Detailed Site Plan Auto Spa Express

DSP-89016-06

STAFF REPORT

SUBJECT: Detailed Site Plan DSP-89016-06
 Auto Spa Express

Figure 1: Typical Architecture

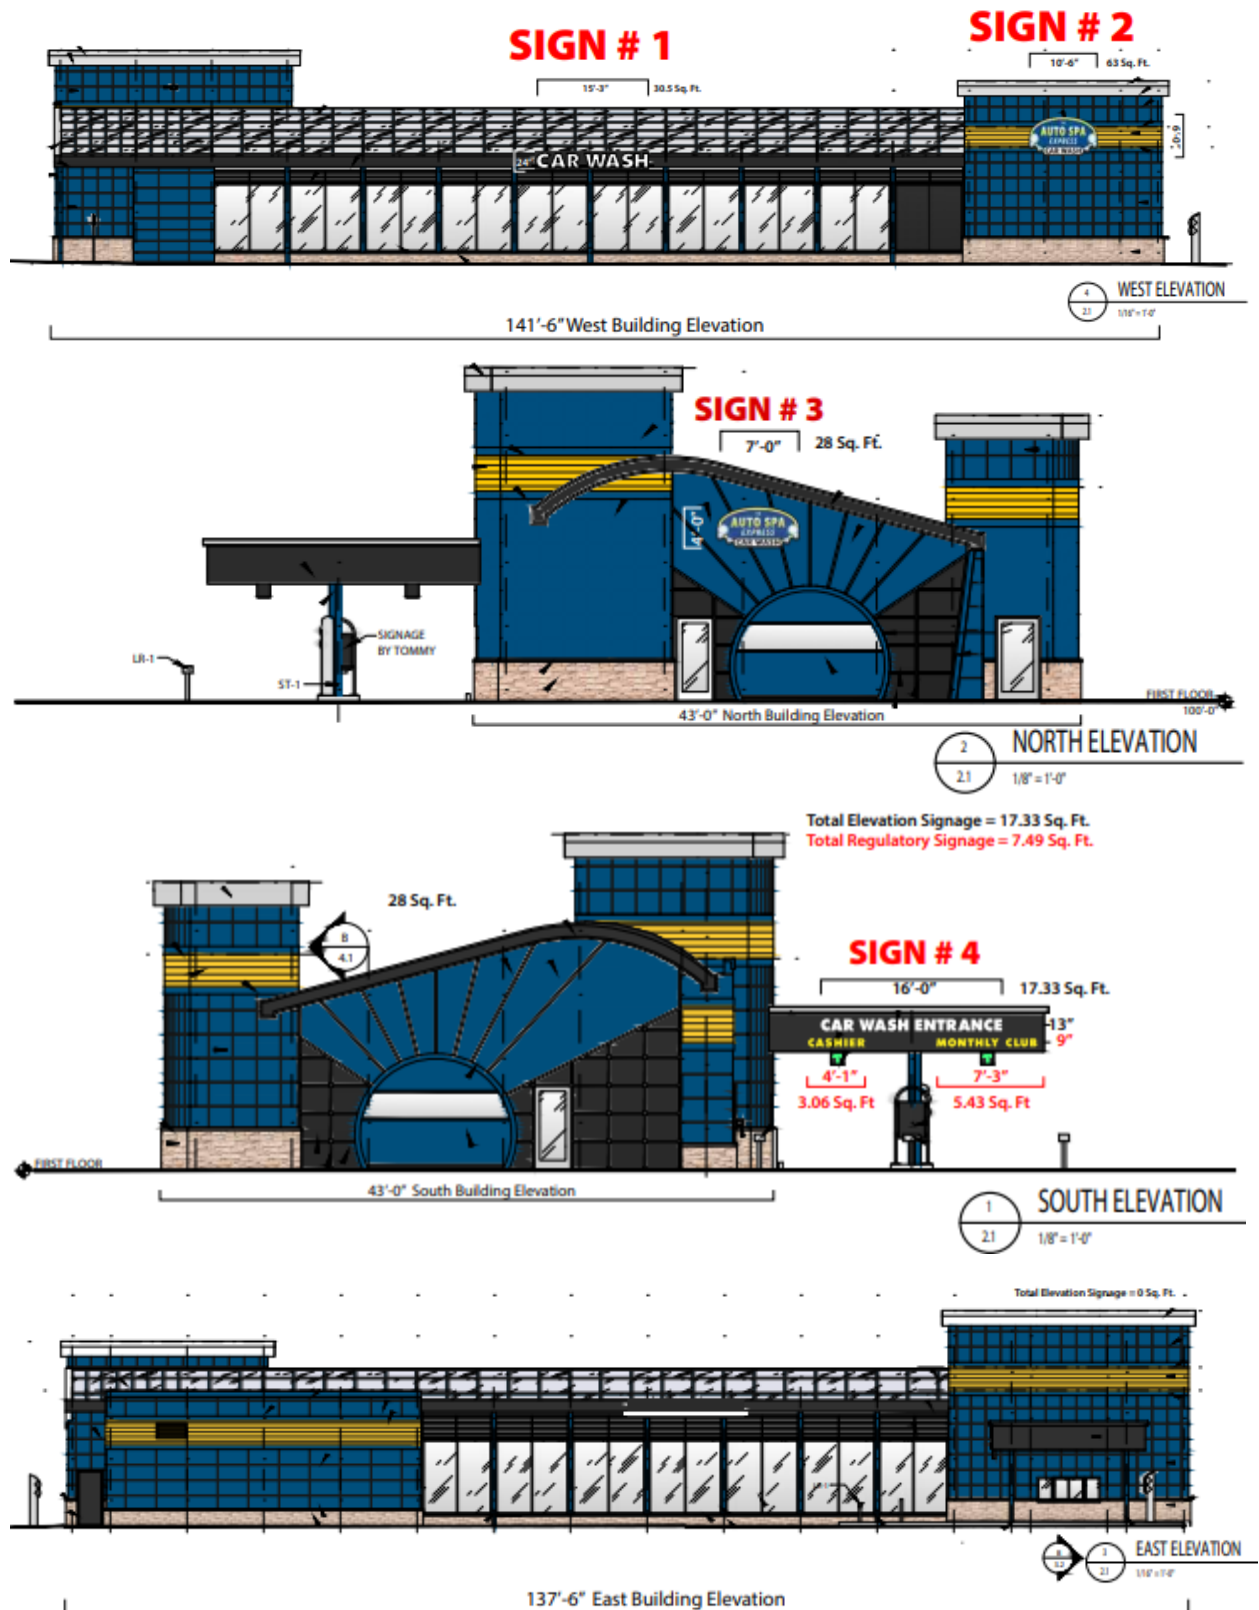
The architectural design of the proposed building is contemporary. The building has an arching roof line, with rectangular corner towers at each end of the building. The exterior finish is comprised of finished metal panels, aluminum slat stock, large windows, and stone veneer.
